Re: Zircaloy Clad  
Conversion  
ISAP Topic 2.17

Haddam Neck Plant  
Additional Information  
Small-Break Loss of Coolant Accident Analysis--  
Zircaloy Clad Fuel

Attachment  
Haddam Neck Plant  
Additional Information

FIGURE 7-1

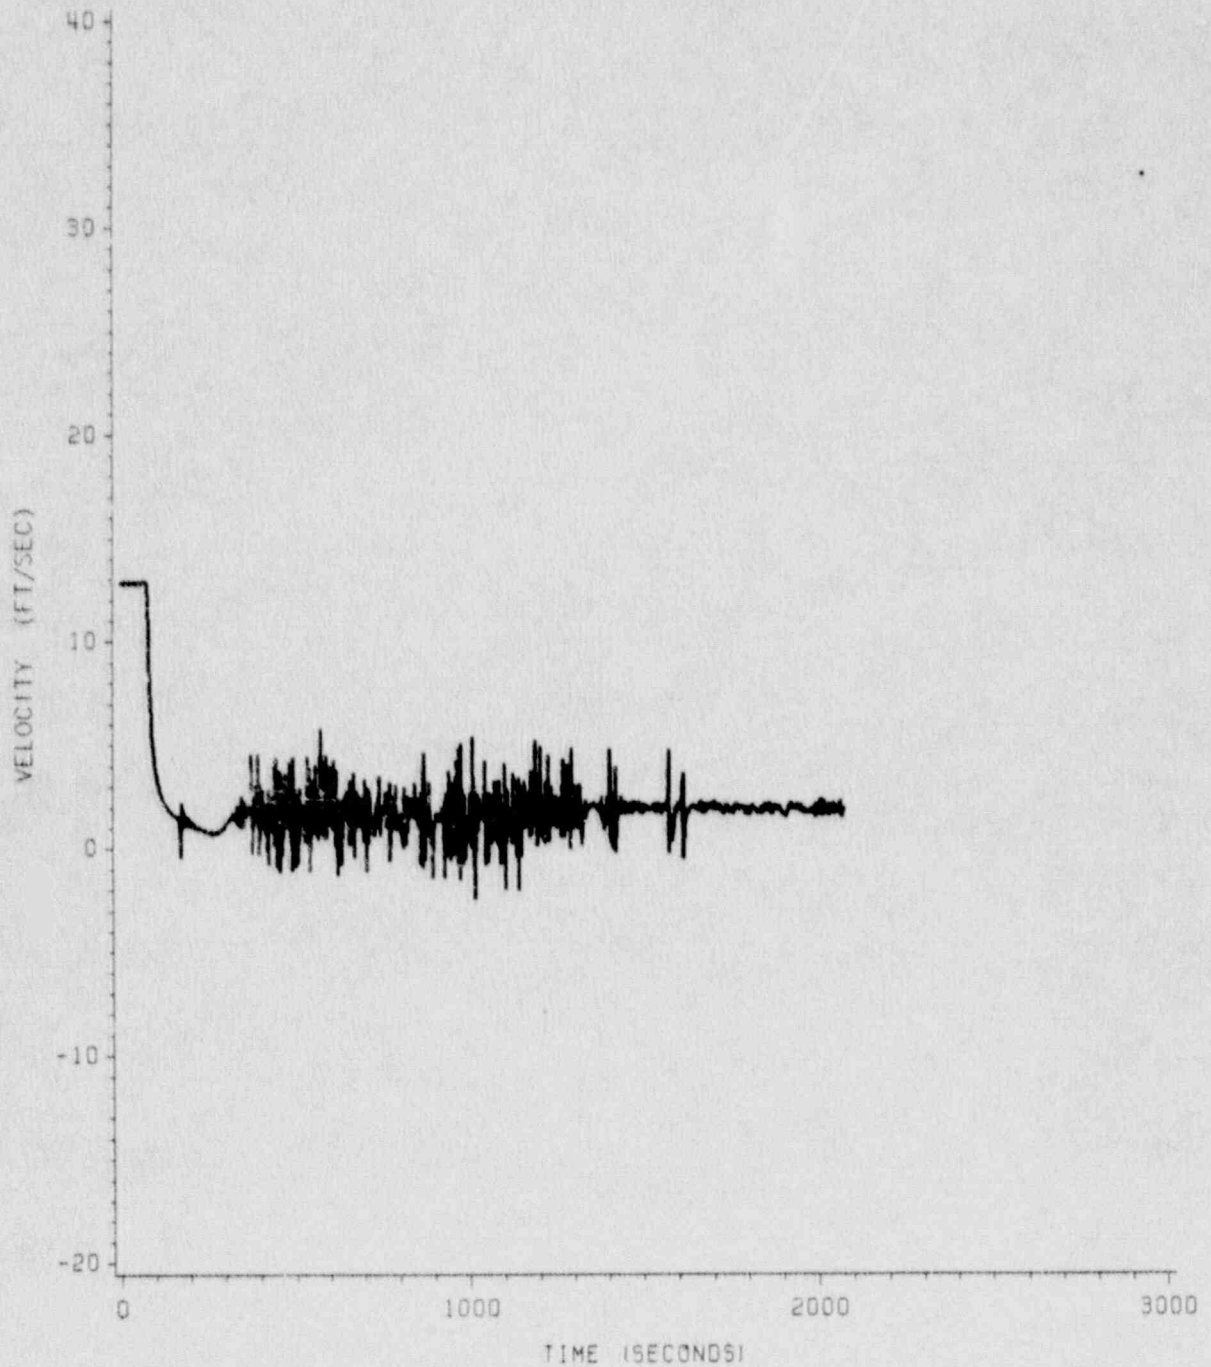
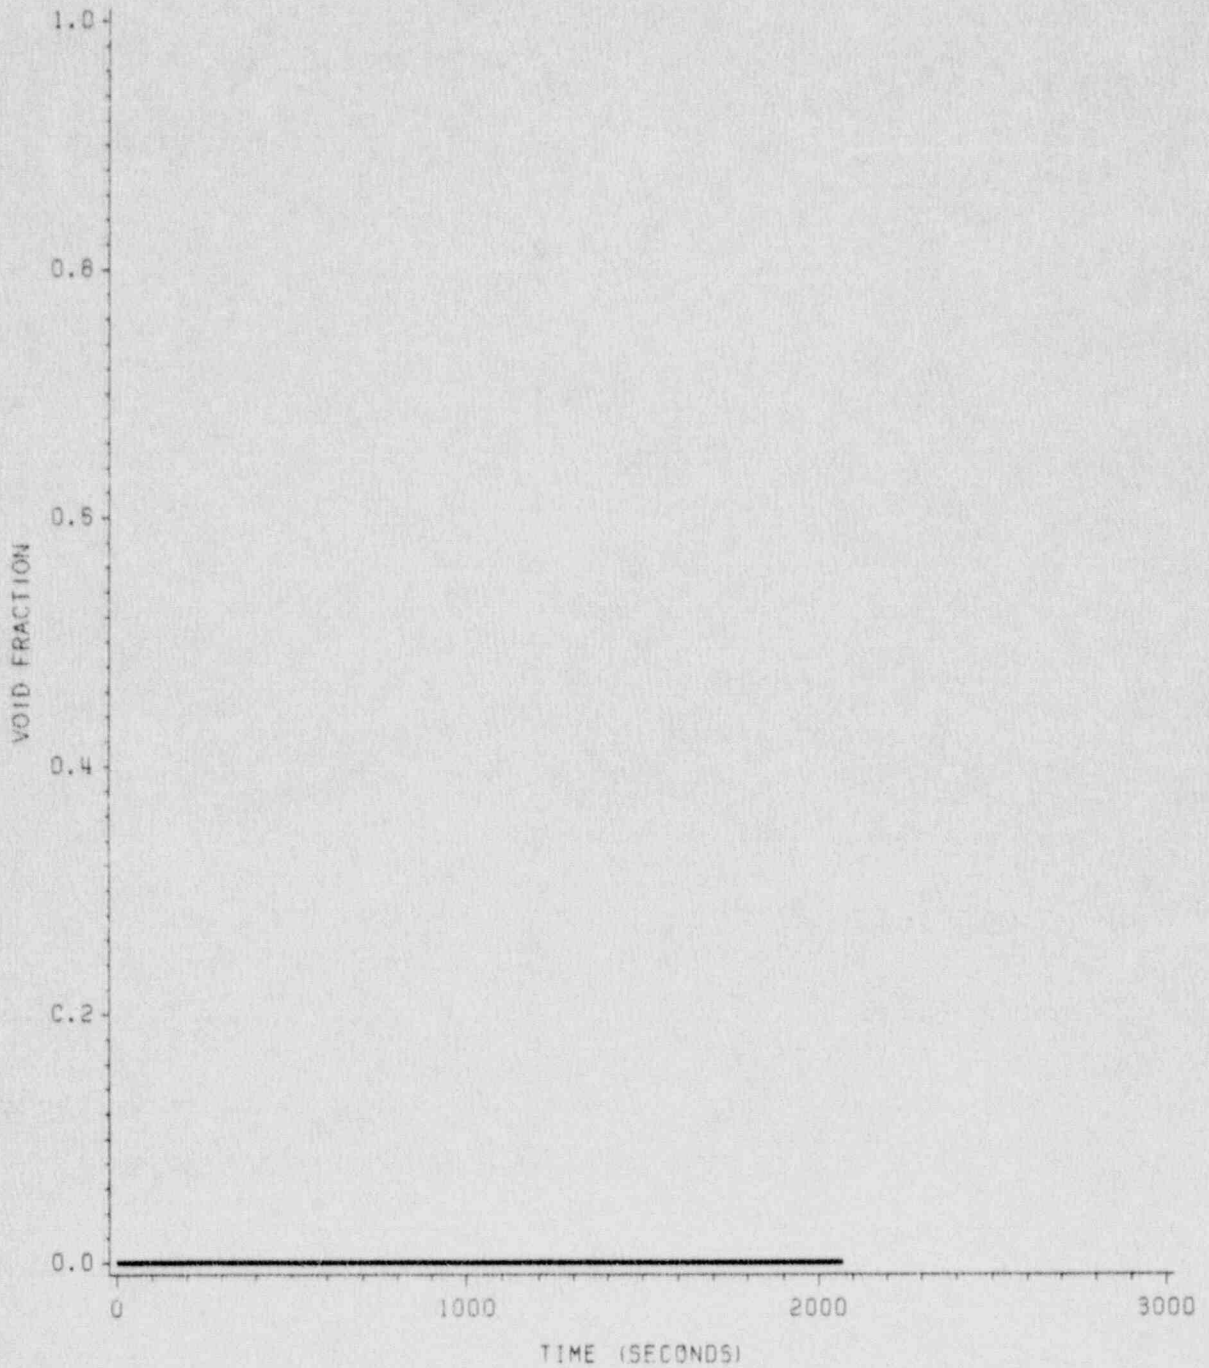
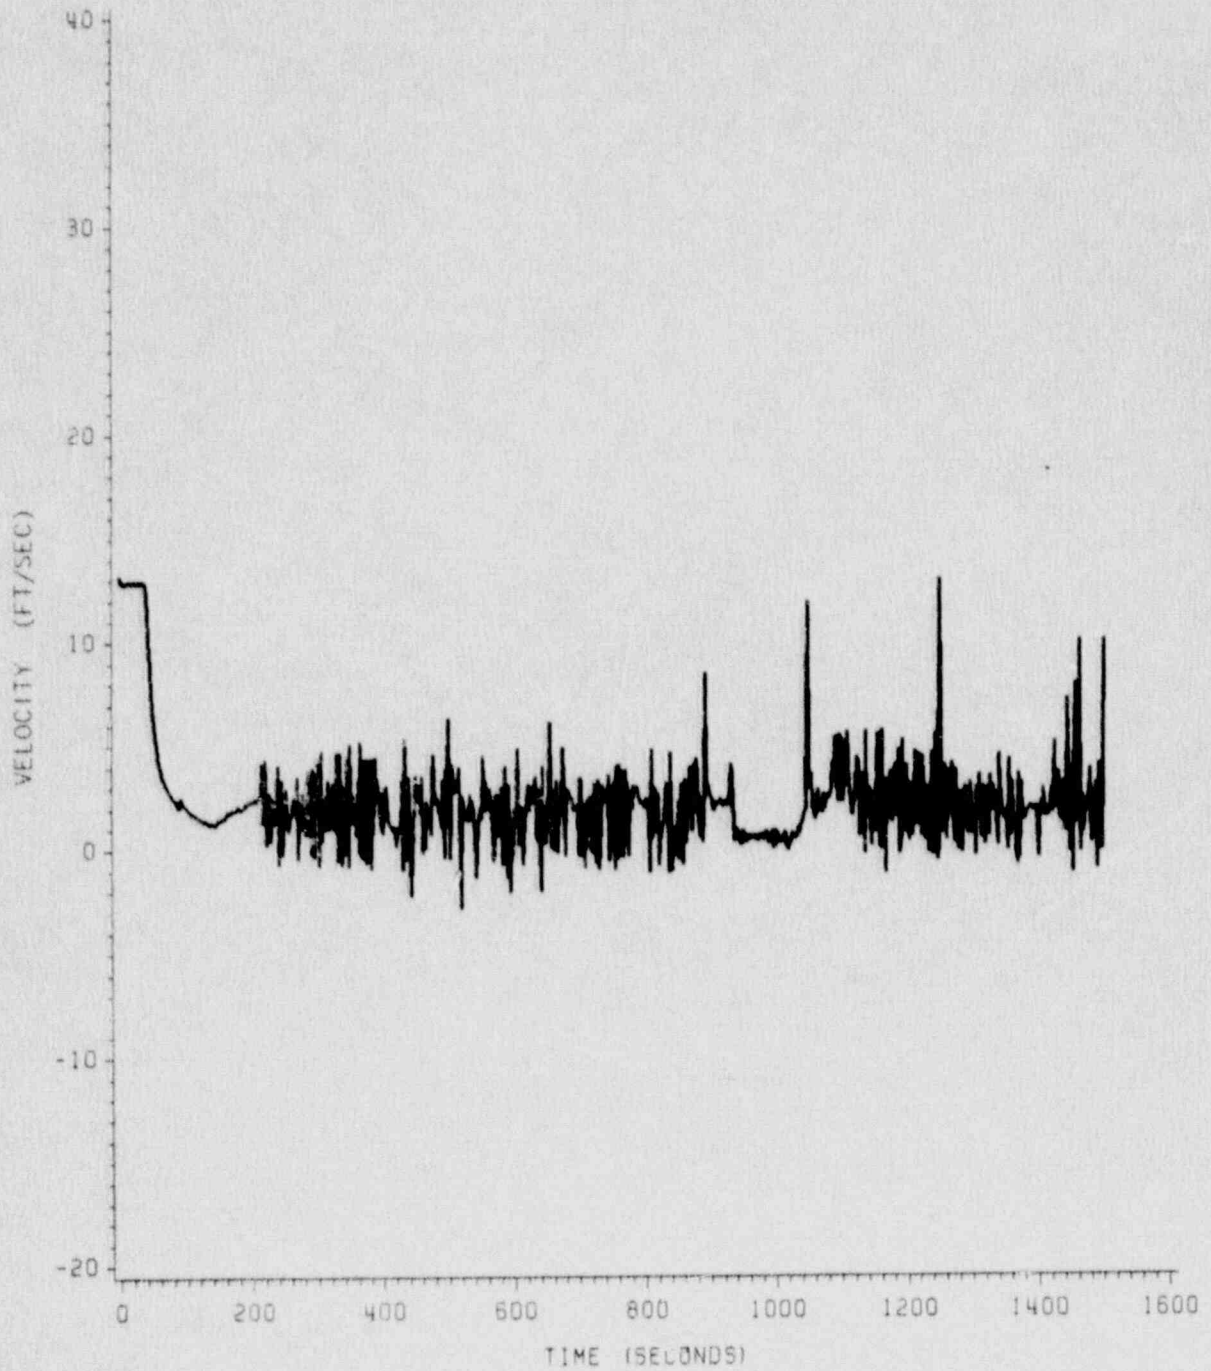
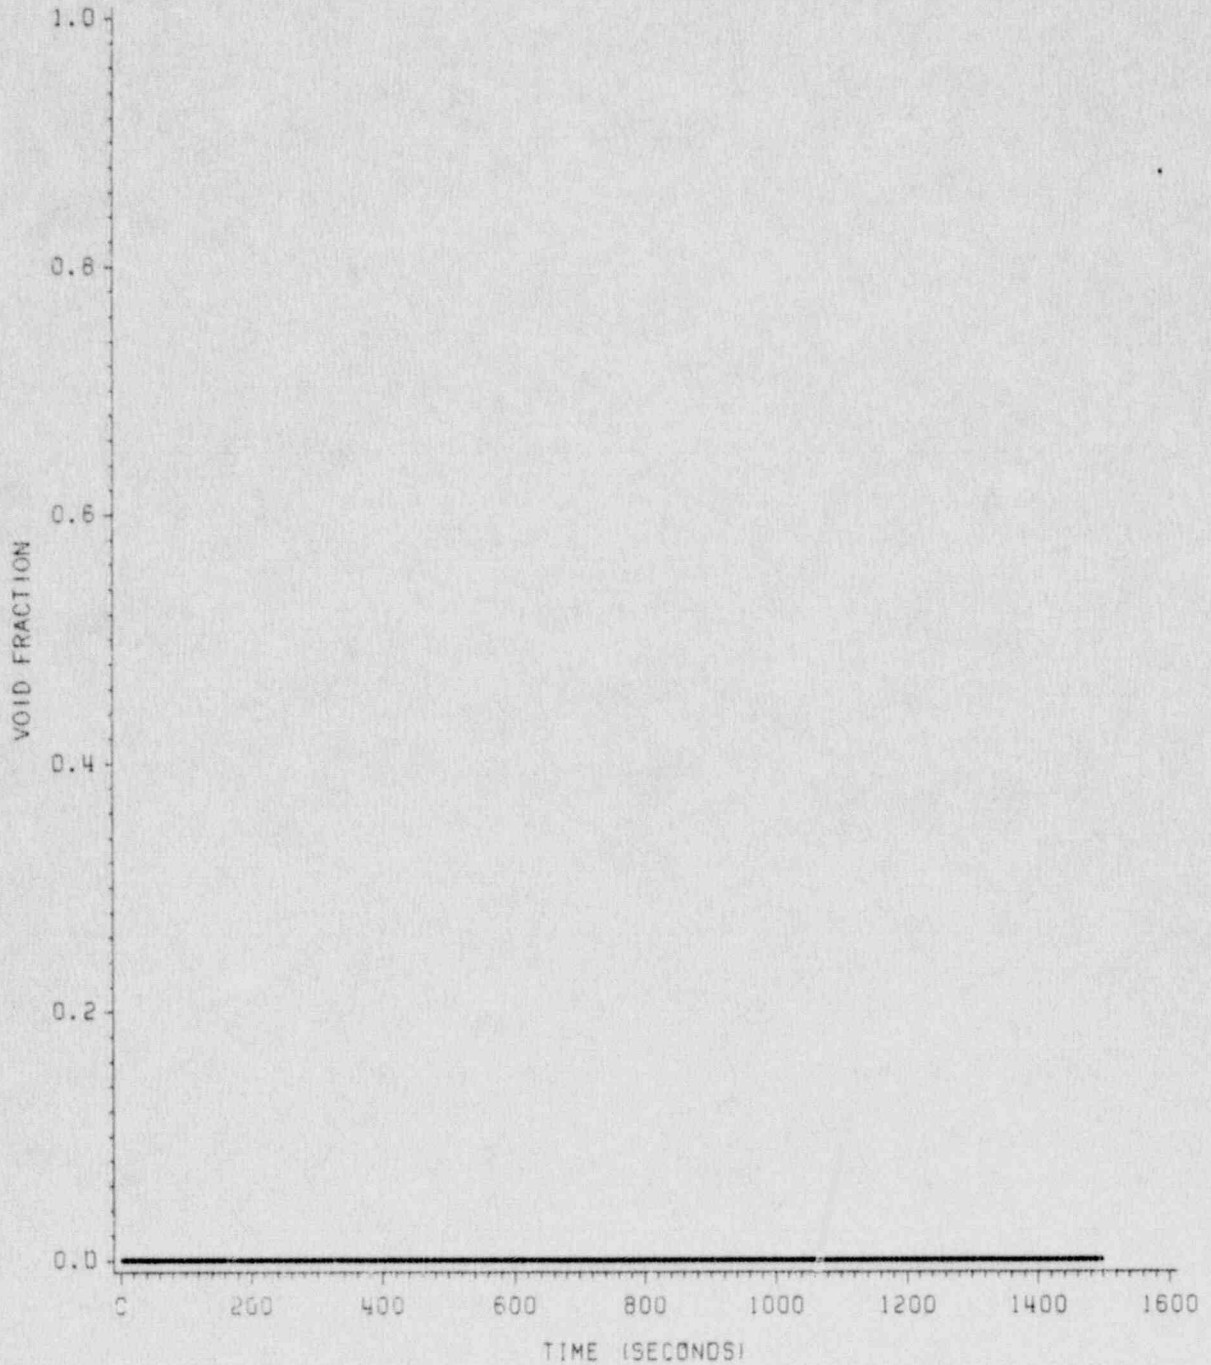
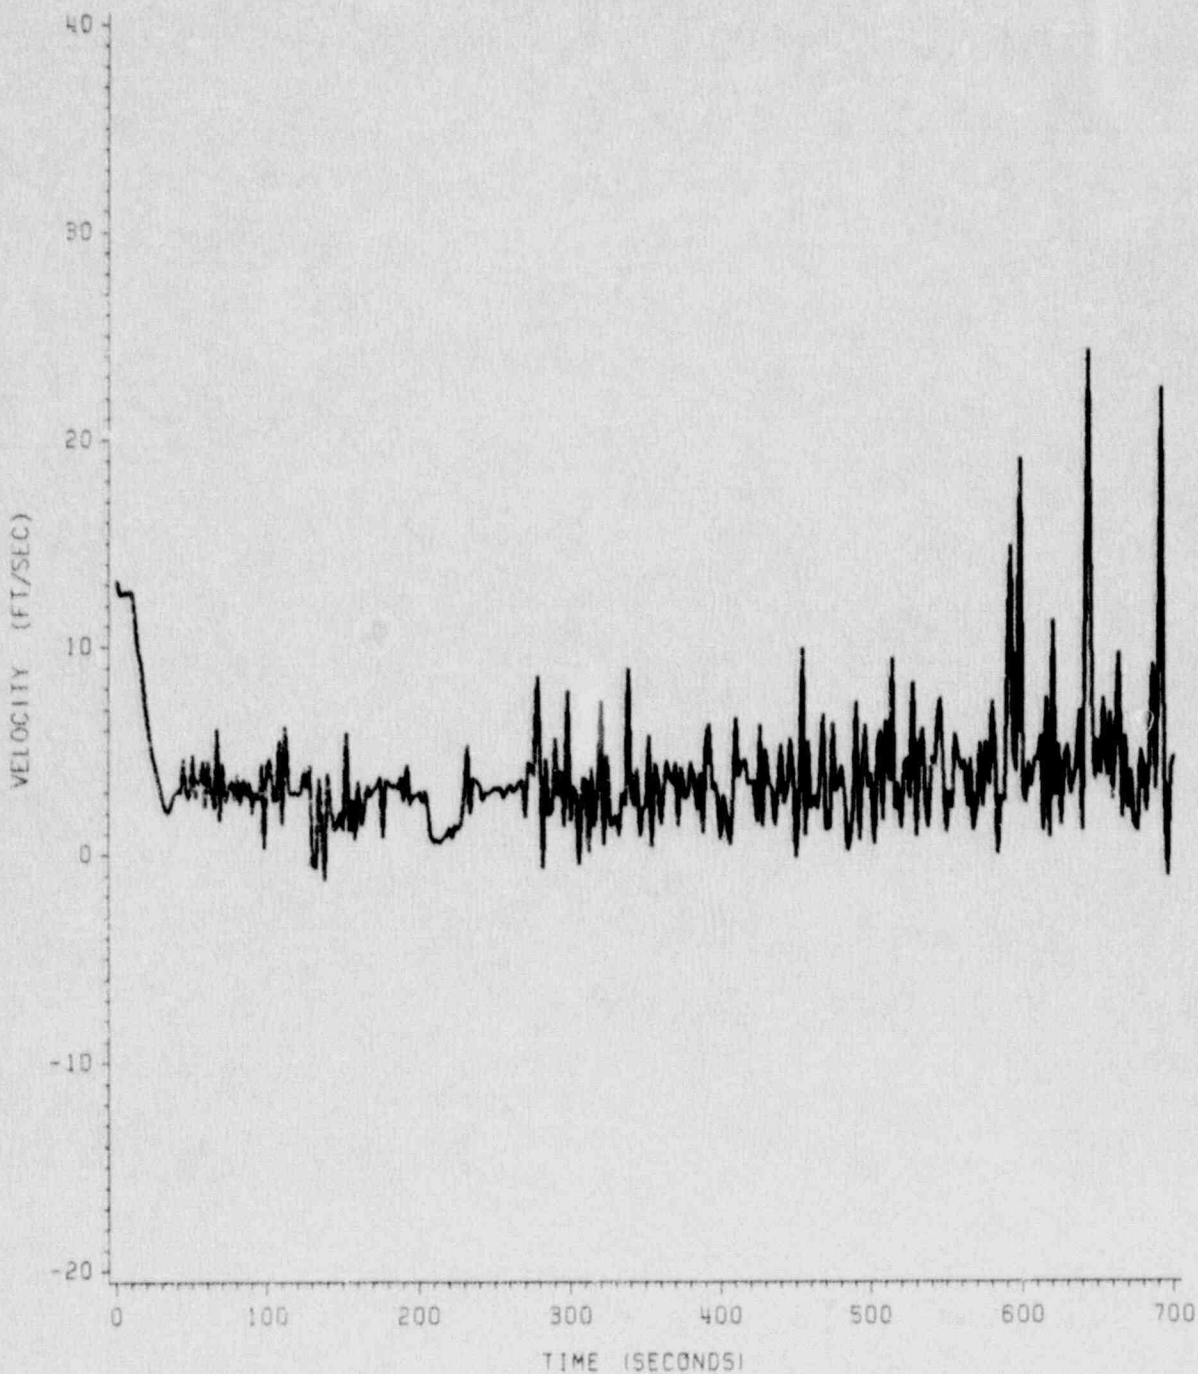
By letter dated August 3, 1988, the staff provided a safety evaluation of the use of the NULAP5 code. Conclusion 7 of the evaluation stated that the licensee committed to review the core thermal-hydraulics and clad temperature response in all future calculations to ensure that the clad temperature increase is not artificially terminated by the existence of mist flow in the upper core during the loop seal clearing uncovering period. Provide evidence of this review.

The clad surface temperatures are provided in NUSCO 163. Collapsed and two-phase level plots are provided in the response to Question 8. Figures 7-1 through 7-12 provide the hot spot vapor velocity and void fraction in lower plenum volume 335 for each of the breaks analyzed in NUSCO 163.

The collapsed and two-phase level plots provide the time frame for the loop seal clearing uncovering period. It can be seen from the clad temperature responses that the clad temperature increase is terminated during or subsequent to the core level recovery period following loop seal clearing for each of the breaks analyzed. In order to terminate the clad temperature increase during the loop seal clearing uncovering period, a sudden increase in hot spot vapor velocity would have to occur resulting in an increase in heat transfer coefficient. An increase in hot spot vapor velocity could potentially be calculated to occur if the lower plenum volume 335 significantly voided as core level approached the minimum value. Generally, the void fraction in volume 335 would have to be greater than approximately 0.6 for this phenomenon to occur. The lower plenum volume 335 void fraction plots provided verify that the void fraction never approaches 0.6 during the loop seal clearing uncovering period.

Based on the above, it was concluded that, for each of the breaks analyzed in NUSCO 163, the clad temperature increases were not artificially terminated by the existence of mist flow in the upper core during the loop seal clearing uncovering period and that no additional analysis was required.
